SECTION 00 91 03

ADDENDUM NO. 3

CSM Bldg 2,4 Mod. Project
Bid #86573

Addendum 3

project no. 2707.01
 sheet no. **P-211R**

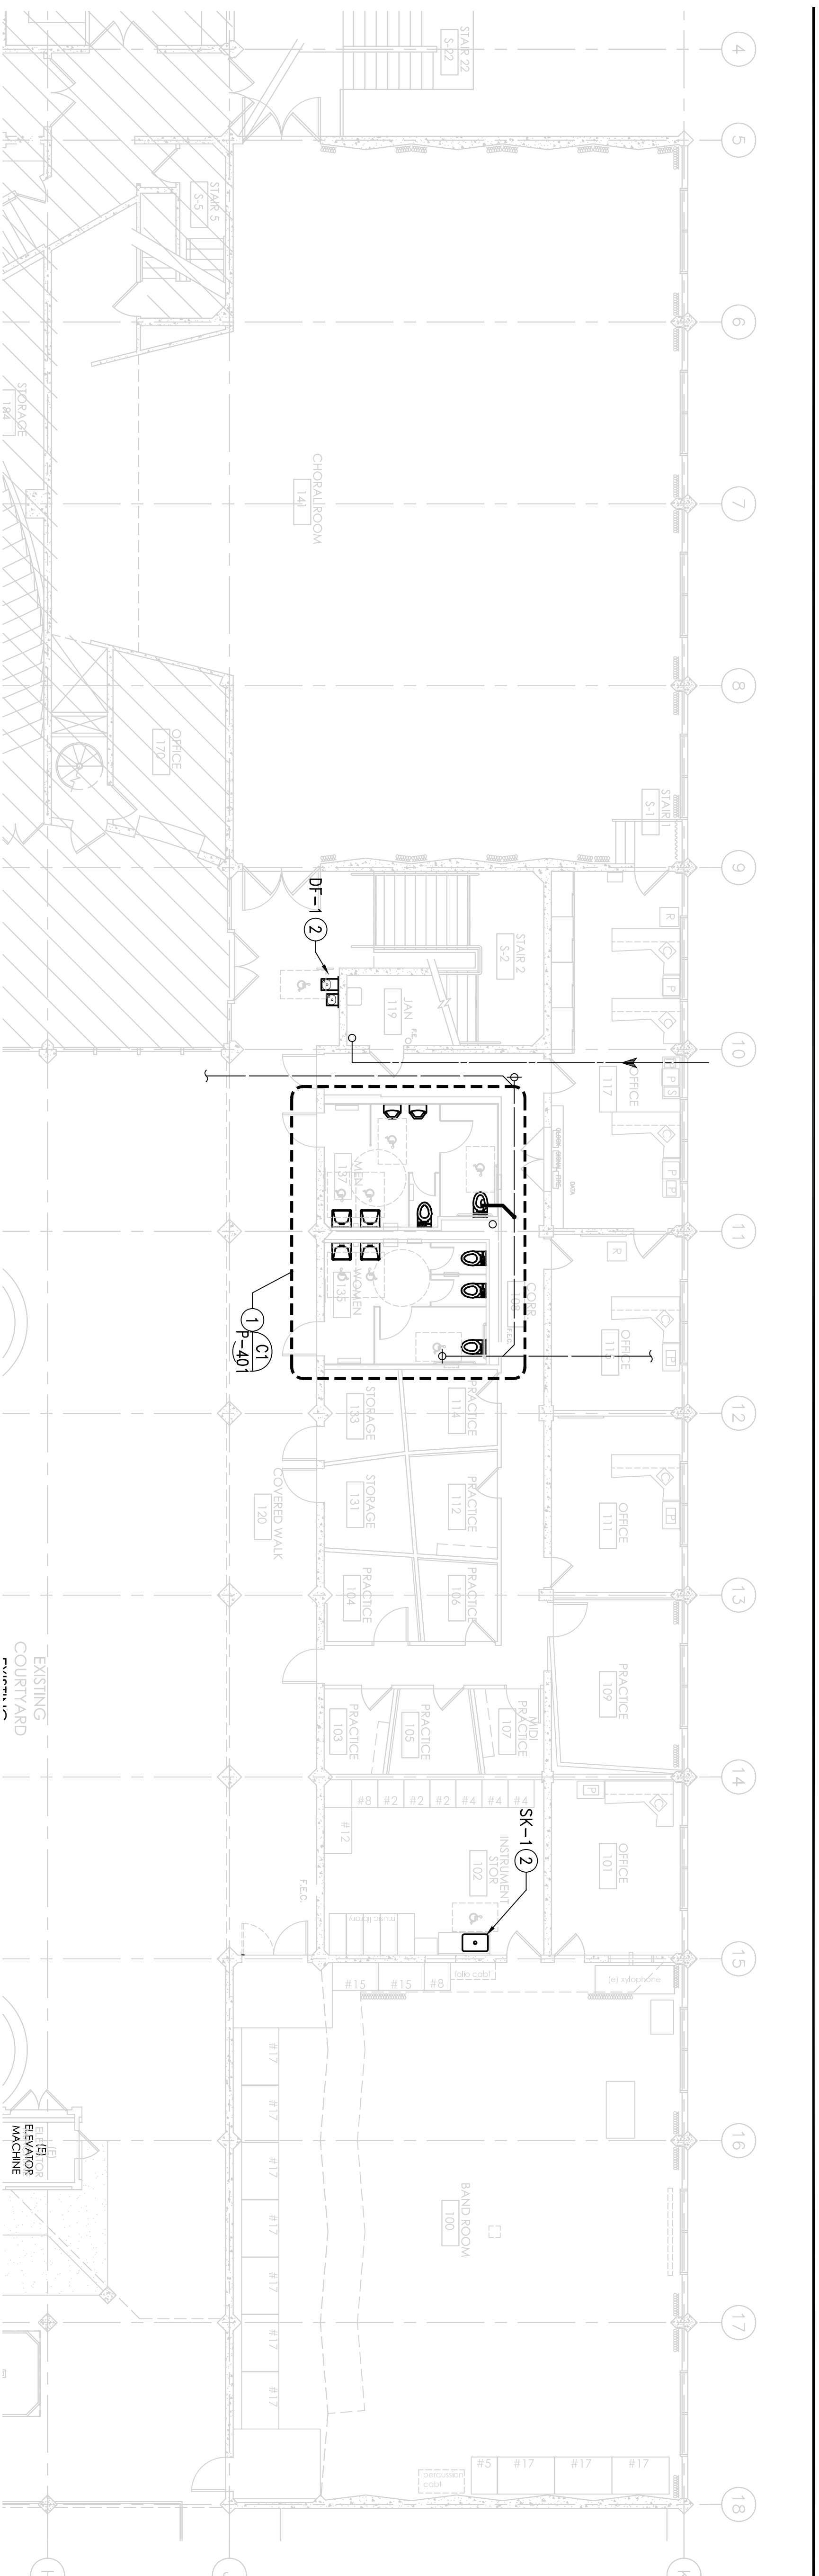
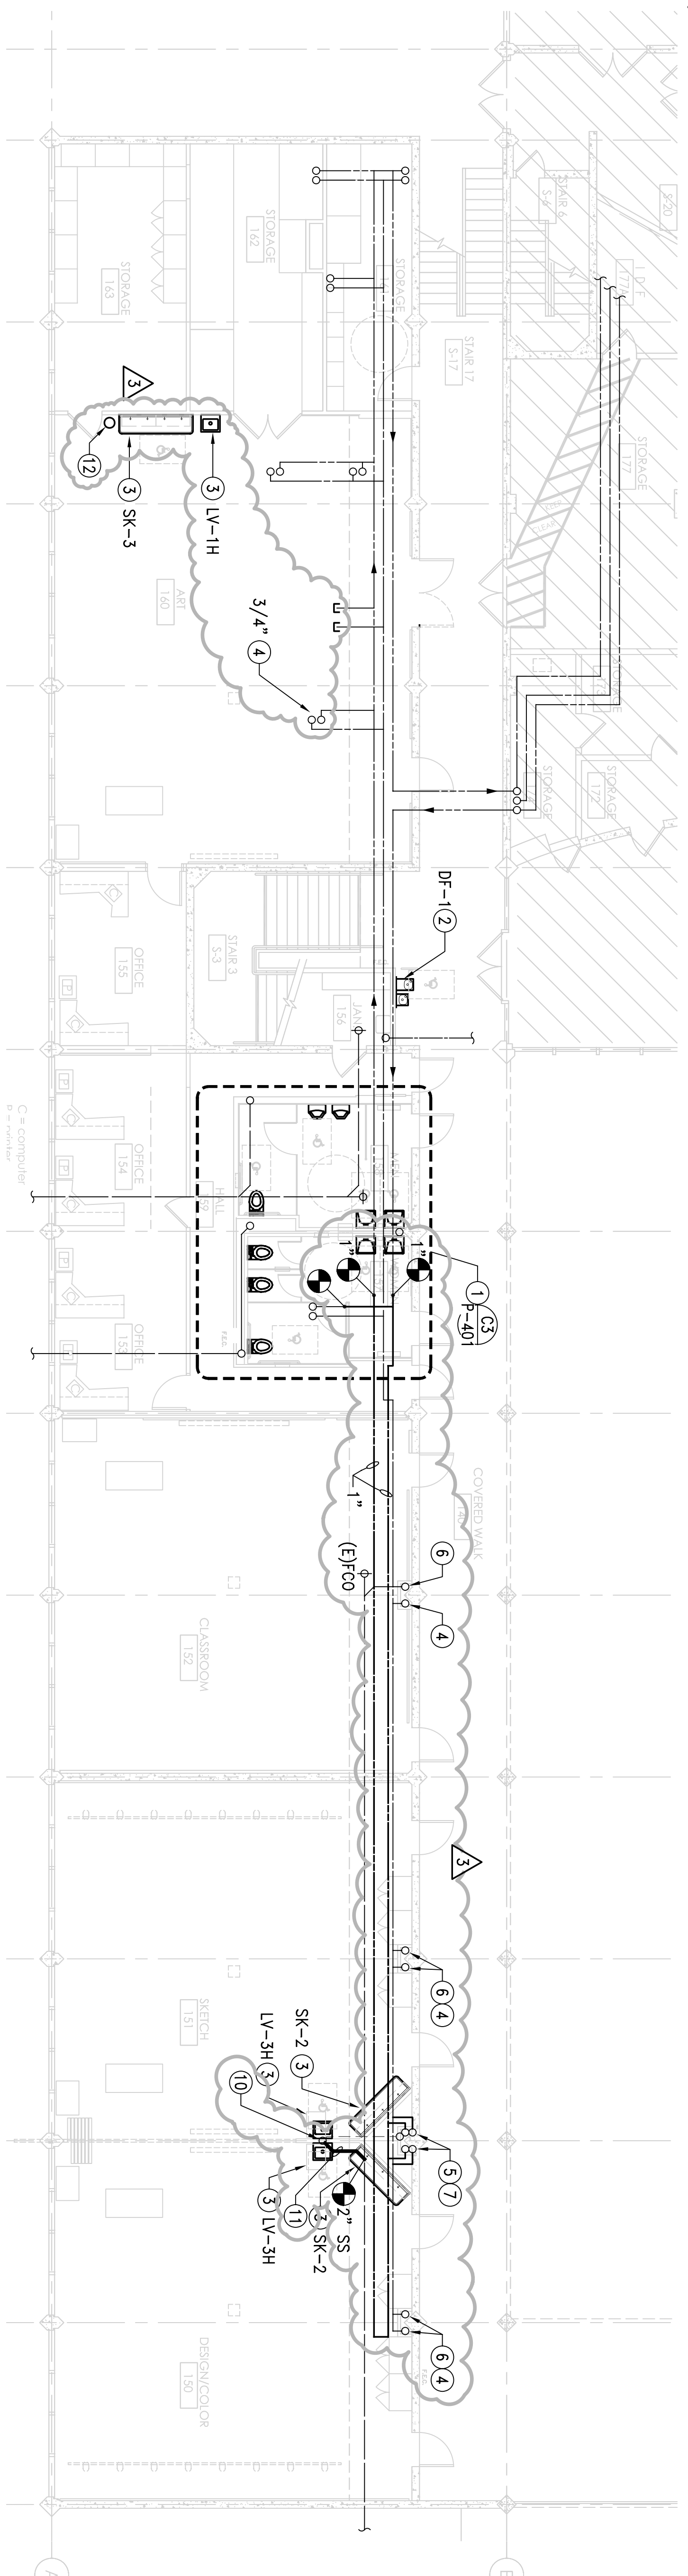
D/P1	Drawing P-001	<ol style="list-style-type: none"> 1. In Plumbing Fixture Schedule, ADD sediment trap specification for SK-3. 2. In Plumbing Fixture Schedule, ADD new photo sink designation, SK-5.
D/P2	Drawing P-111	<ol style="list-style-type: none"> 1. In Building 4 floor plan, ADD existing hot water, hot water return and cold water piping. 2. ADD new Sheet Notes 5 through 10.
D/P3	Drawing P-112	<ol style="list-style-type: none"> 1. In Building 4 floor plan, ADD existing plumbing risers up from below. 2. ADD new Sheet Notes 6 through 11.
D/P4	Drawing P-211	<ol style="list-style-type: none"> 1. In Building 4, ADD hot water to classroom sinks and lavatories. 2. ADD new Sheet Notes 4 through 12. 3. ADD sediment trap to SK-3 in Art Room 160.
D/P5	Drawing P-212	<ol style="list-style-type: none"> 1. In Darkroom 266, ADD two faucets and mixing valves for existing photo sink designated SK-5. 2. ADD or REPLACE mixing valves for existing photo sinks in Photo rooms 268, 269 and 270.. 3. ADD hot water for classroom sink and lavatory. 4. ADD new Sheet Notes 5 through 12.

- 1 SEE DETAIL INDICATED FOR NEW WORK.
- 2 NEW PLUMBING FIXTURE. CONNECT TO (E) ROUGH-INS.
- 3 EXTEND EXISTING SS, SV, HW AND/OR CW TO NEW PLUMBING FIXTURE
- 4 (E) 1/2" CW UP TO 2ND FLOOR, UON.
- 5 NEW 3/4" HW & CW DOWN.
- 6 (E) 2" SS DOWN FROM ABOVE.
- 7 NEW 1-1/2" SV UP TO 2ND FLOOR.
- 8 NEW 1/2" HW UP TO 2ND FLOOR.
- 9 EXTEND NEW HW & CW TO NEW SINKS.
- 10 2" SS DOWN THRU SLAB TO (E) BUILDING DRAIN. EXTEND 1-1/2" SV TO (E) VENT UP.
- 11 SAW CUT FLOOR FOR INSTALLING NEW PIPING.
- 12 SEDIMENT TRAP ON FLOOR. CONNECT FROM NEW SINKS AND TO EXISTING SS AND V.
